CAMPUS WIDE, REPLACEMENT/REHAB SAN SEWER SYSTEM CAT 5.5
South Dakota State University
Brookings, South Dakota
OSE# R0323--03X/ARPA
2024

ADDENDUM NO. 1

November 6, 2024

G - EROSION CONTROL
EROSION CONTROL PLAN
 SHEET NO. **G106**

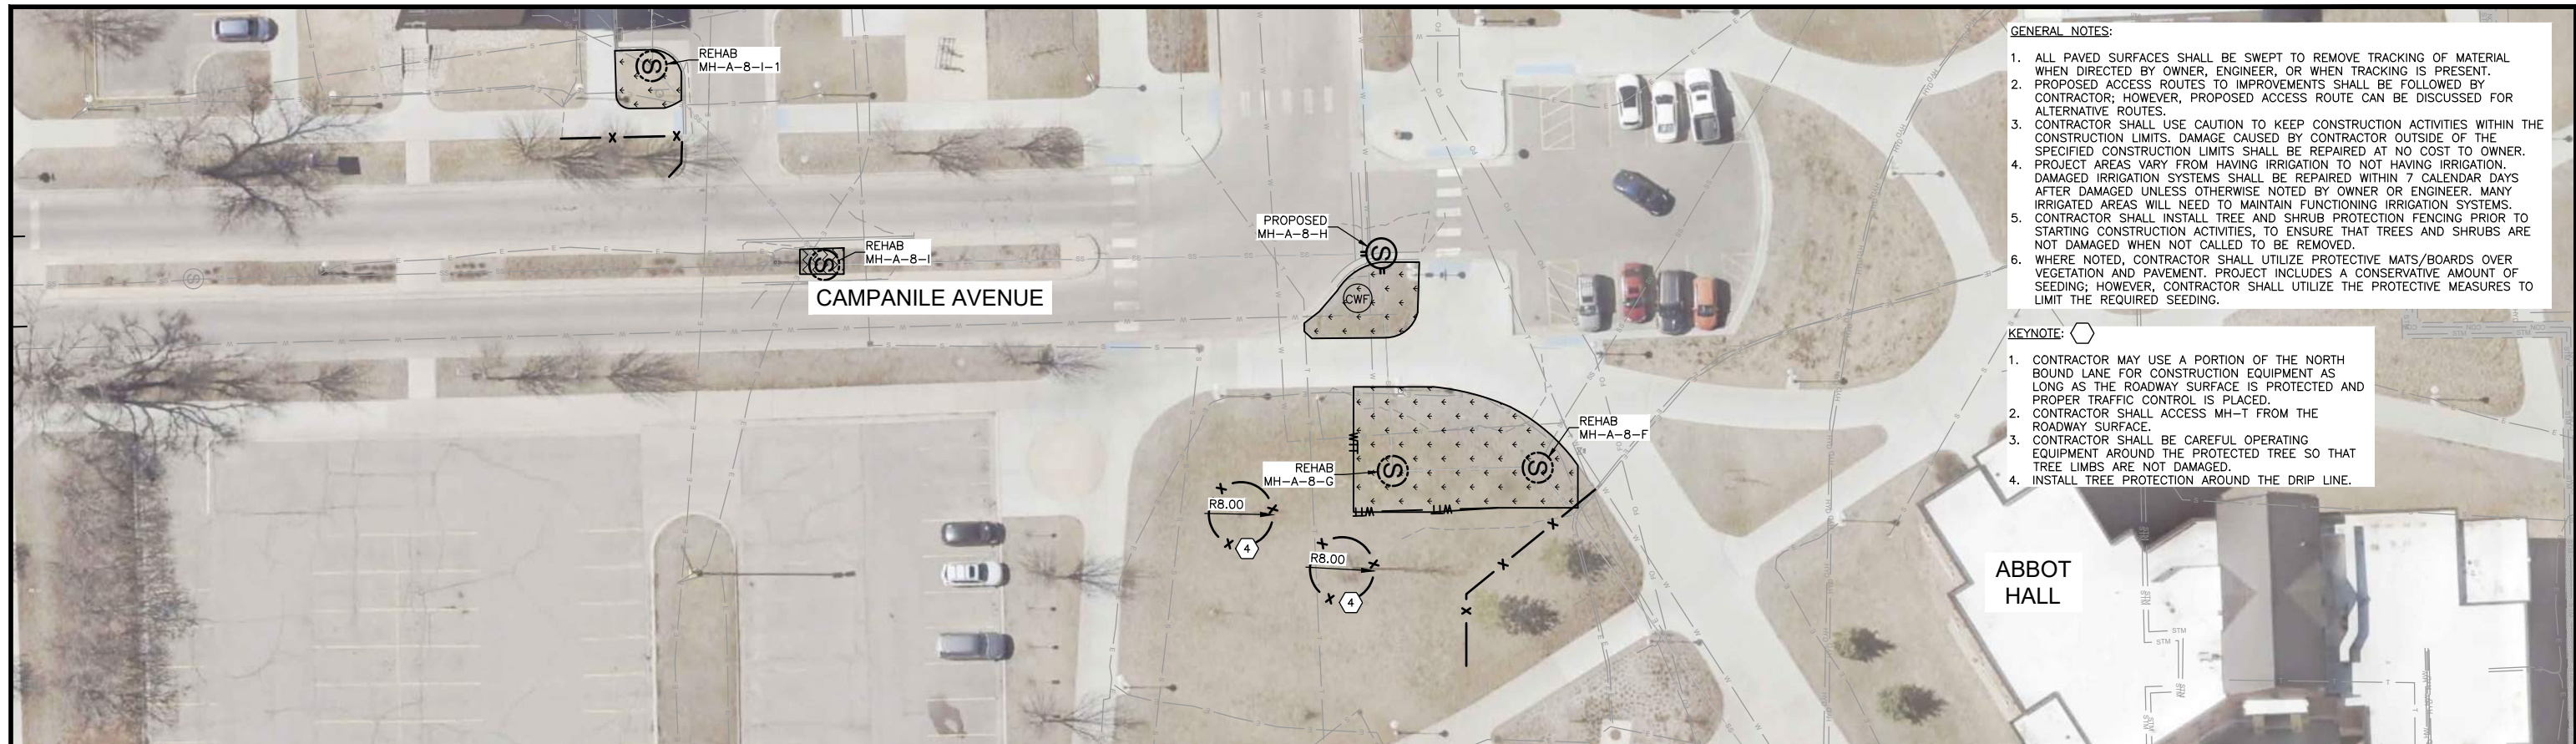
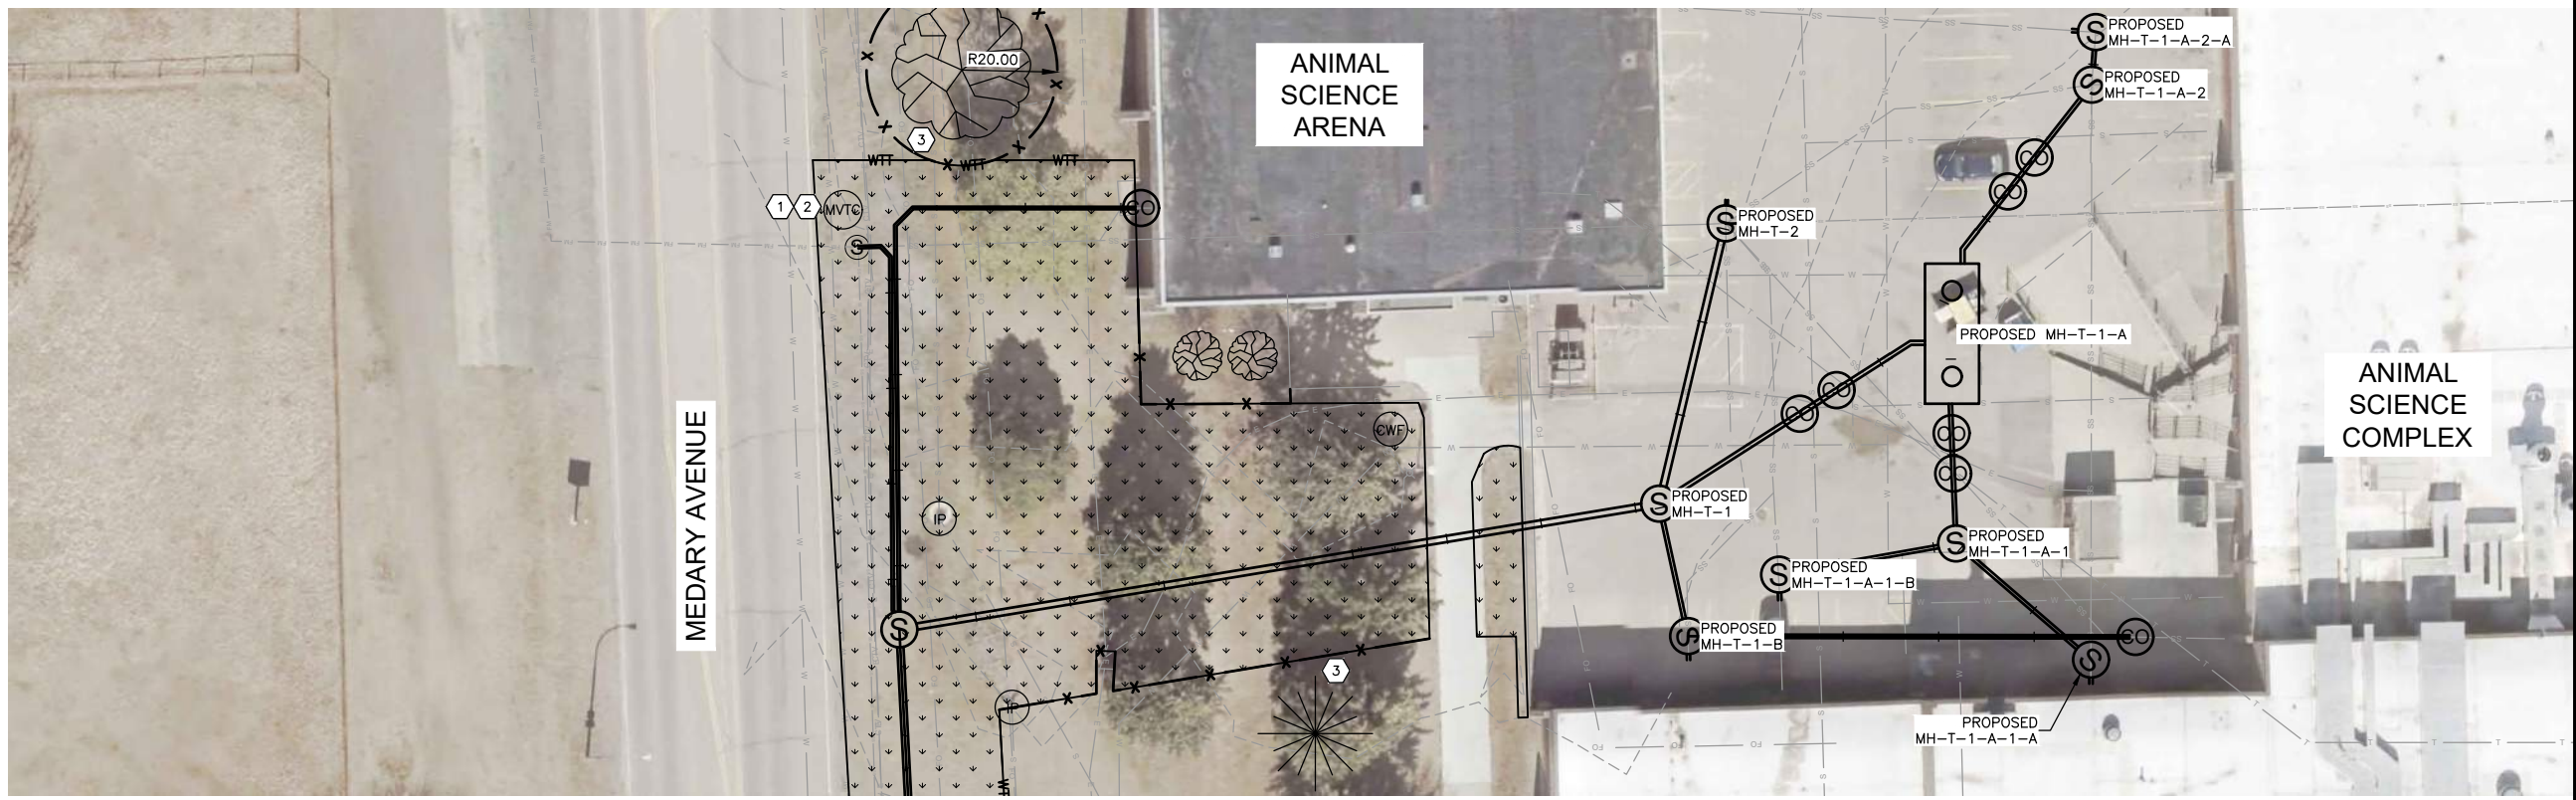
Added tree protection limits.

SHEET NO.
G116

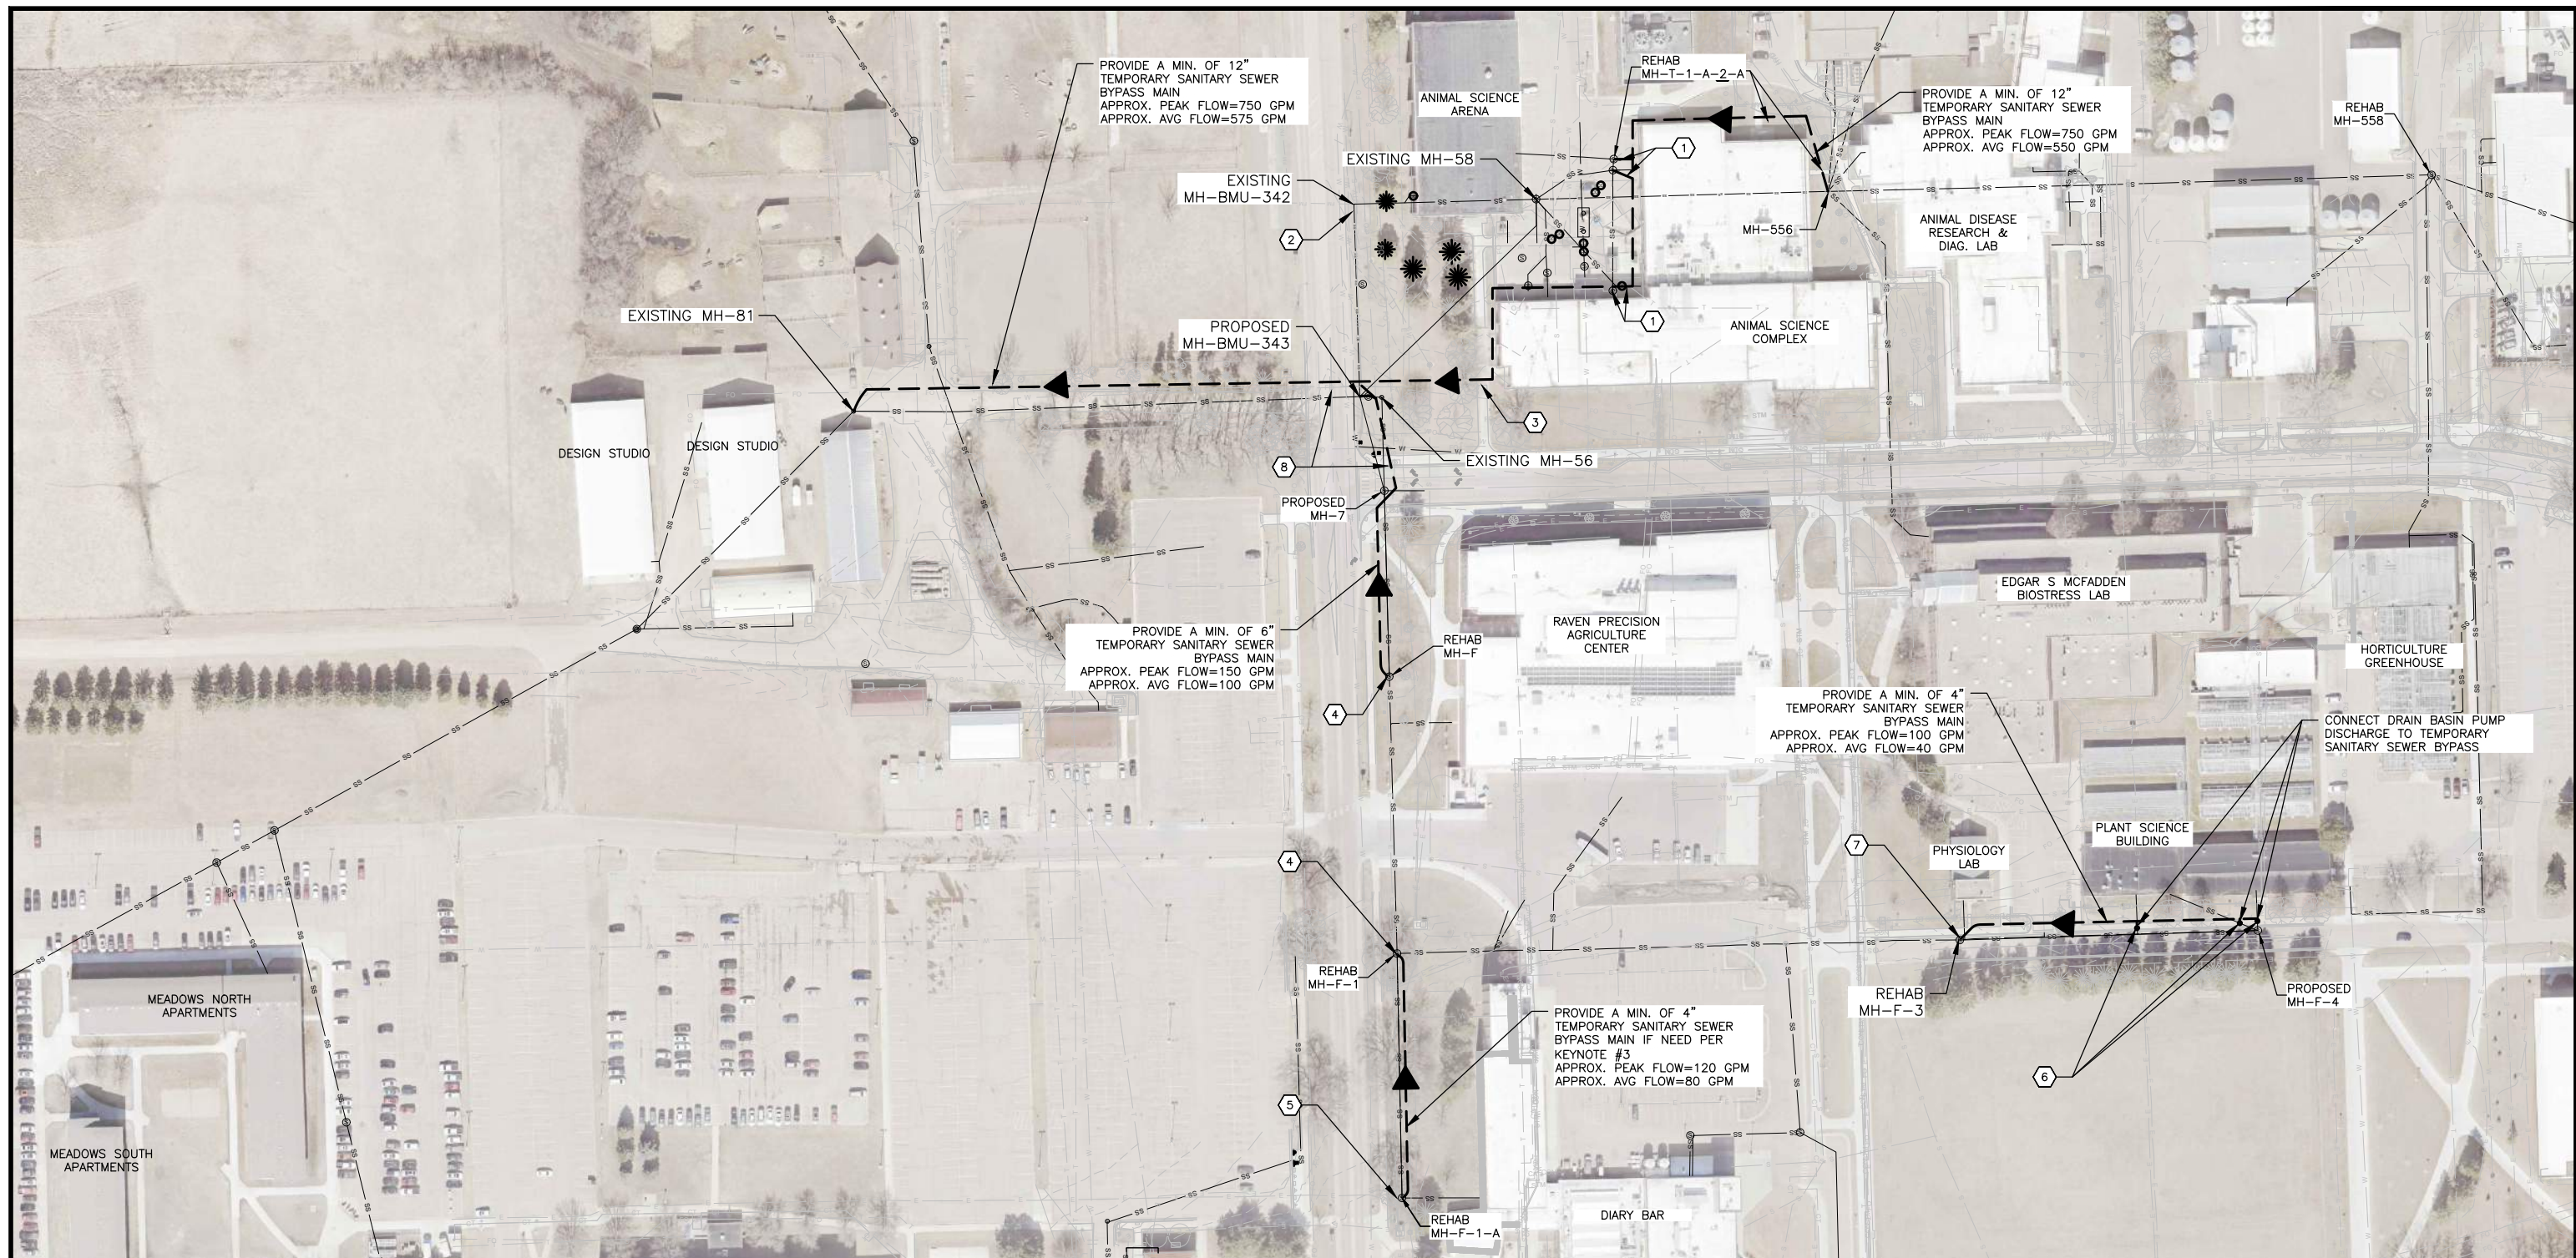
Modified Detail, ORGANIC MULCH PLANT BEDS.

SHEET NO.
H104

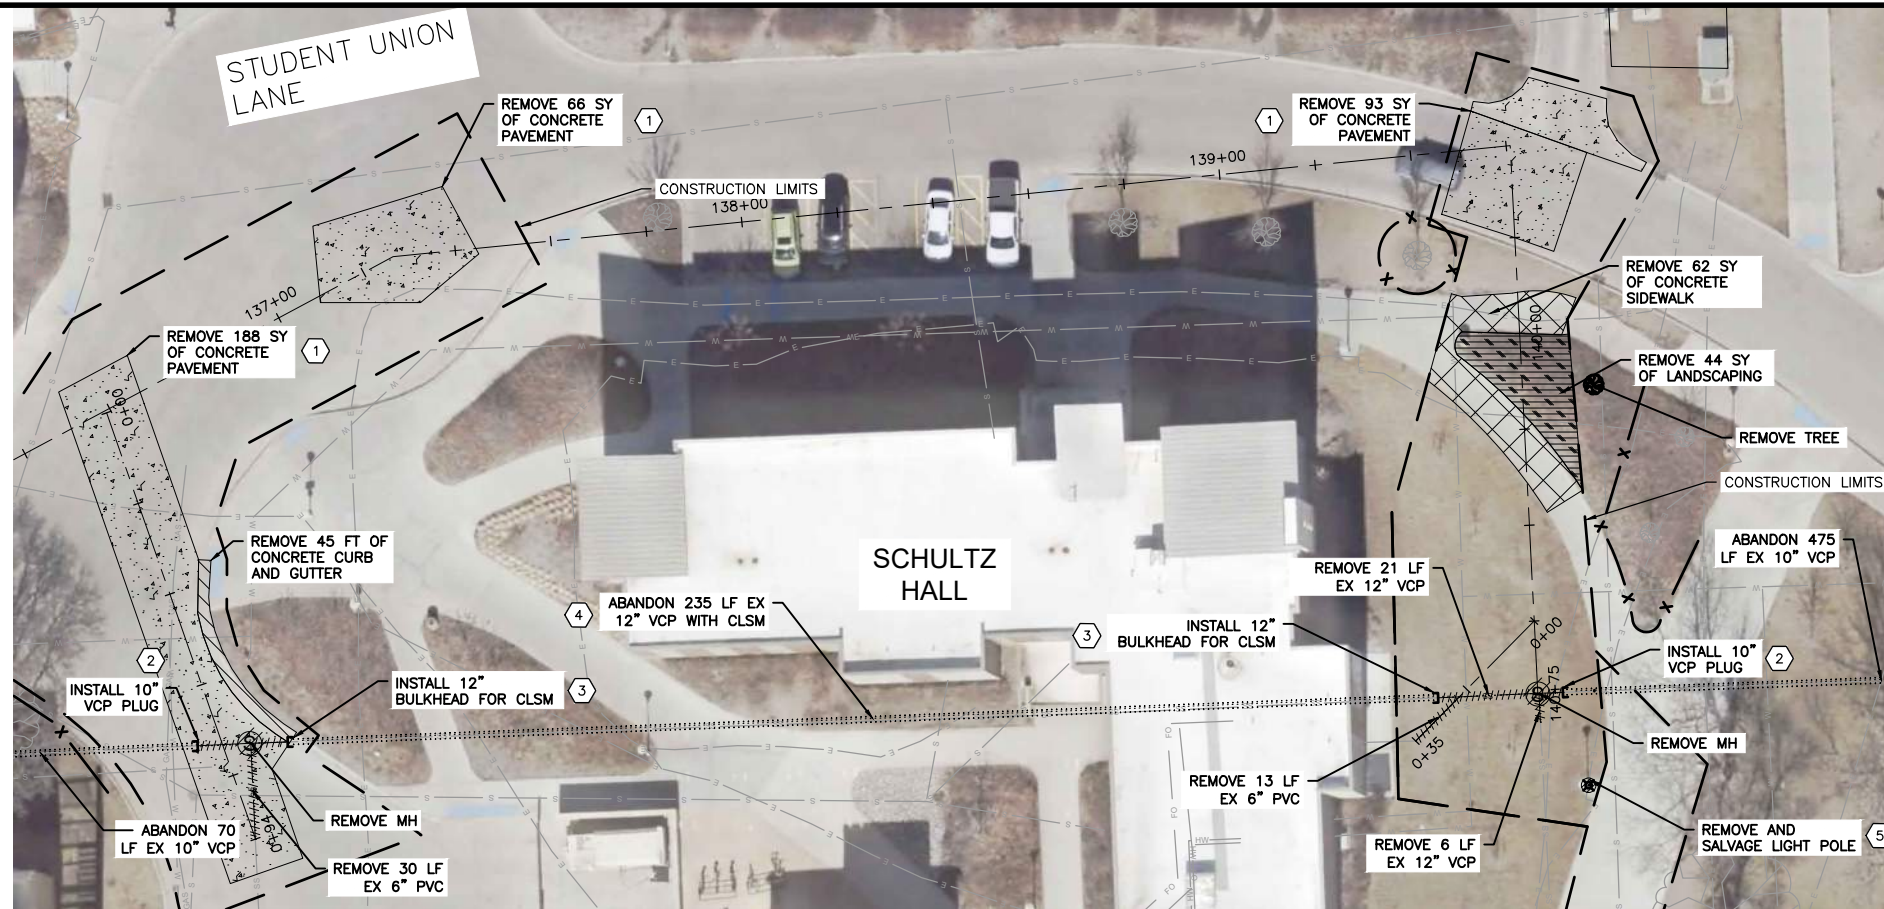
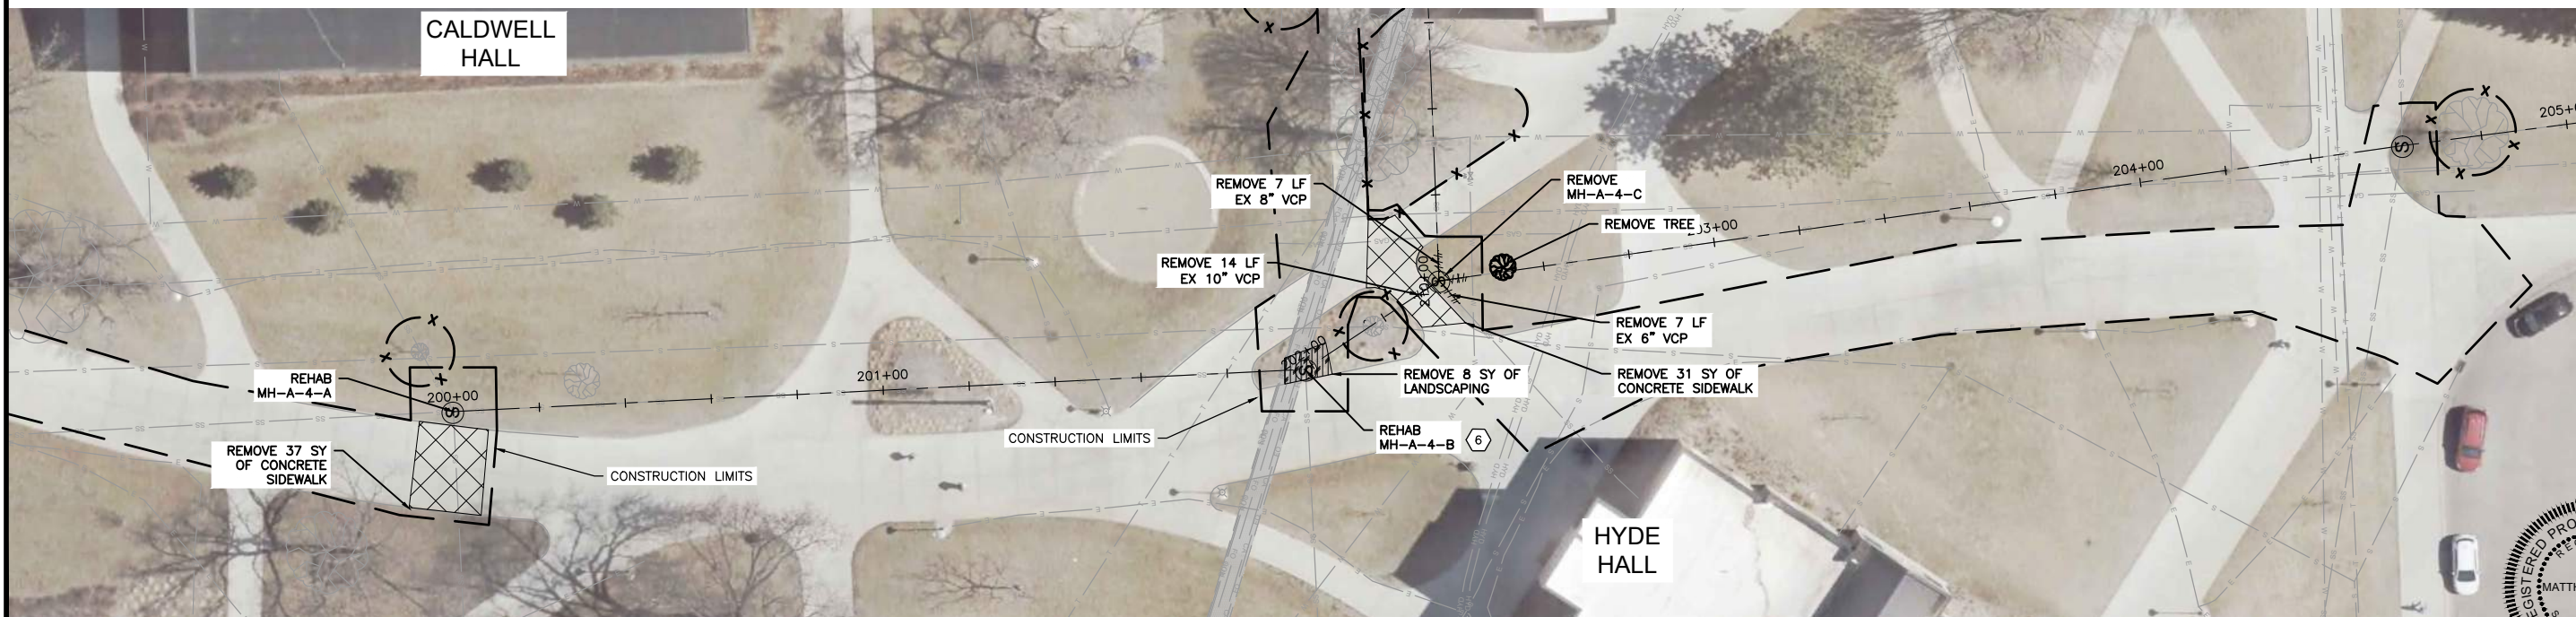
Added tree removal.
